# Access Compliance Report

## Public Rights-of-Way

Intersection ID: 11619	Main Street: E_15TH_ST	Cross Street: N_CALDWELL_ST	Location: N
ADA ID: 45370D5E4919	Ramp Type: PerpDiag	Initial Pass/Fail: Fail	Overall Compliance: No
Severity Score: 21.25			
Codes/Mitigation Info/Possible Solution		Field Measurements/Component Compliance

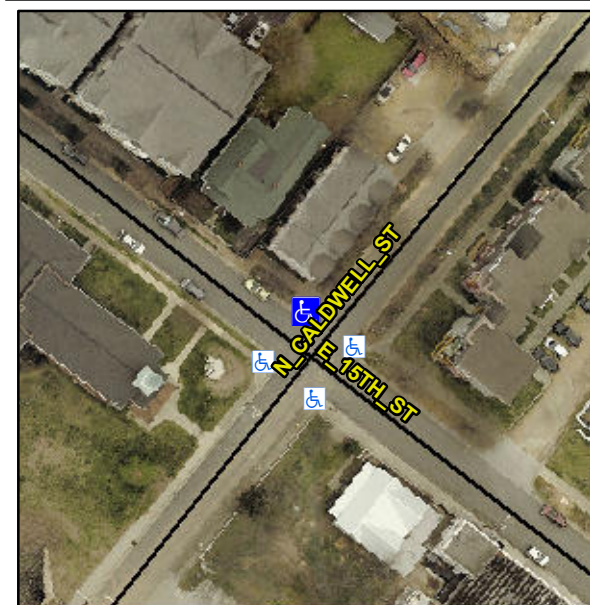
Compliance	Description	Data	Compliance	Description	Data
N/A	Ramp Length (in)	76.0	No	Ramp Slope (%)	8.6
No	Ramp Width (in)	41.0	Yes	Ramp XSlope (%)	1.3
N/A	Flare Type LT	N/A	N/A	Flare Type RT	N/A
N/A	Flare Slope LT (%)	N/A	N/A	Flare Slope RT (%)	N/A
N/A	Flare Traversable LT?	N/A	N/A	Flare Traversable RT?	N/A
N/A	Landing Length (in)	N/A	N/A	DWS Provided?	N/A
N/A	Landing Width (in)	N/A	N/A	DWS Contrast?	N/A
N/A	Landing Slope (%)	N/A	N/A	DWS Length (in)	N/A
N/A	Landing X Slope (%)	N/A	N/A	DWS Full Width?	N/A
N/A	Landing Curb? (Y/N)	N/A	N/A	DWS Offset (in)	N/A
N/A	Shared Landing?	N/A			
N/A	Gutter Ponding?	N/A	N/A	Gutter Slope (%)	N/A
N/A	Gutter Lip Ht (in)	1.5	N/A	Gutter X Slope (%)	N/A
N/A	Painted X Walk1?	No	N/A	Painted X Walk2?	No
	X Walk 1 Direction	To SW		X Walk 2 Direction	To SE
N/A	X Walk 1 Width (in)	N/A	N/A	X Walk 2 Width (in)	N/A
	X Walk 1 Slope (%)	2.8		X Walk 2 Slope (%)	4.6
	X Walk 1 X Slope (%)	3.1		X Walk 2 X Slope (%)	1.6

**Remove & Replace Curb Ramp With Two New Directional Ramps or Equivalent.**
